Access Compliance Report

Public Rights-of-Way

(Curb Ramps)

Intersection ID: 28132	Main Street: LAHINCH_CT	Cross Street: PORTMARNOCK_CT	Location: SE
ADA ID: 498145286D5A	Ramp Type: PerpDiag	Initial Pass/Fail: Pass	Overall Compliance: No
			Severity Score: 30.25

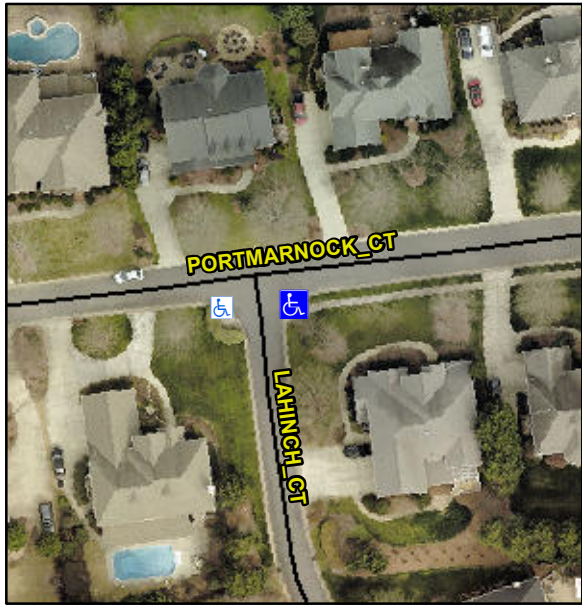
Codes/Mitigation Info/Possible Solution			Field Measurements/Component Compliance					
	Possible Solutions:		Compliance	Description	Data	Compliance	Description	Data
	Remove & Replace Curb Ramp With Two New Directional Ramps or Equivalent. Remove & Replace Gutter.		N/A	Ramp Length (in)	49.5	Yes	Ramp Slope (%)	5.2
			Yes	Ramp Width (in)	123.0	No	Ramp XSlope (%)	2.9
			N/A	Flare Type LT	Sloped	N/A	Flare Type RT	N/A
			N/A	Flare Slope LT (%)	2.3	N/A	Flare Slope RT (%)	N/A
			N/A	Flare Traversable LT?	No	N/A	Flare Traversable RT?	No
			Yes	Landing Length (in)	49.0	No	DWS Provided?	No
			Yes	Landing Width (in)	72.0	N/A	DWS Contrast?	No
			No	Landing Slope (%)	4.5	N/A	DWS Length (in)	N/A
			No	Landing X Slope (%)	3.5	N/A	DWS Full Width?	No
		N/A	Landing Curb? (Y/N)	No	N/A	DWS Offset (in)	N/A	
		N/A	Shared Landing?	No				
		Yes	Gutter Ponding?	No	No	Gutter Slope (%)		9.9
		No	Gutter Lip Ht (in)	1.5	Yes	Gutter X Slope (%)		1.8

N/A	Painted X Walk1?	No	N/A	Painted X Walk2?		No
			X Walk 1 Direction	To N		X Walk 2 Direction		To W
		N/A	X Walk 1 Width (in)	N/A	N/A	X Walk 2 Width (in)		N/A
			X Walk 1 Slope (%)	4.6		X Walk 2 Slope (%)		2.7
			X Walk 1 X Slope (%)	0.7		X Walk 2 X Slope (%)		4.9
		N/A	Ramp inside XWalk1?	N/A	N/A	Ramp inside XWalk2?		N/A
			Road Slope (%)	5.3	N/A	Clear Space?		Yes
			Road X Slope (%)	8.3	N/A	Clear Space to XWalk (in)		N/A
		Yes	Any Obstructions?	No	Yes	Storm Grate/Utility Hazard?		No
			Obstruction Type			Storm Grate/Utility Type		
				N/A				N/A
					Yes	Surface Condition? (G/P)		Good
